Interactive comment on “Bilinear pressure diffusion and termination of bilinear flow in a vertically fractured well injecting at constant pressure” by Patricio-Ignacio Pérez D. et al.

Received and published: 14 April 2020

Fig. 1. Figure 3: Spatial evolution of isobars $P_N=0.01$ and $P_N=0.05$ over time through the modeling domain, for the dimensionless fracture conductivities $T_D=0.3$ (a, b, c) and $T_D=6.3$ (d, e, f).

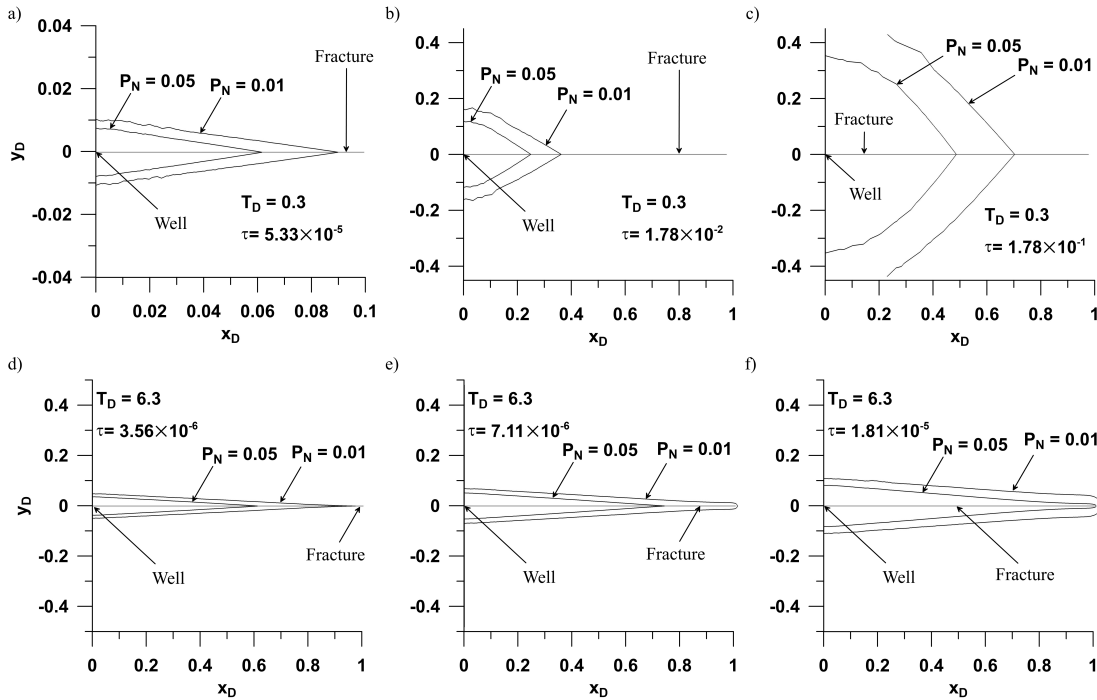
Additionally, in order to show the evolution of isobars we incorporated to the manuscript Figure 3 (added also to this reply), which displays simulation results of pressure contours through the computational domain in a 2D cross section for the dimensionless fracture conductivities $T_D=0.3$ and $T_D=6.3$ for three different times. We chose these values of T_D because they represent two interesting and illustrative scenarios. Furthermore, we introduced the following text in section 3.1 “Propagation of isobars along the fracture and the matrix”, just after the definition of P_N , “The isobars behave differently depending on the value of T_D . For cases with low T_D , it is distinguishable that after the termination of bilinear flow, the isobars reveal a tendency of progressing toward an elliptical or pseudo-radial flow while still propagating along the fracture (see, for example, $T_D= 0.3$ in Fig. 3 a, b, c). The lower the value of T_D , the more pronounced this tendency becomes. On the other hand, for high T_D the behavior of the isobars is similar to the formation linear flow beyond the fracture (see $T_D= 6.3$ in Fig. 3 d, e, f). Although the behavior of isobars after the termination of bilinear flow is also highly interesting, this aspect is not addressed in further detail in this work. It remains pending to be studied in a follow-up investigation.”.
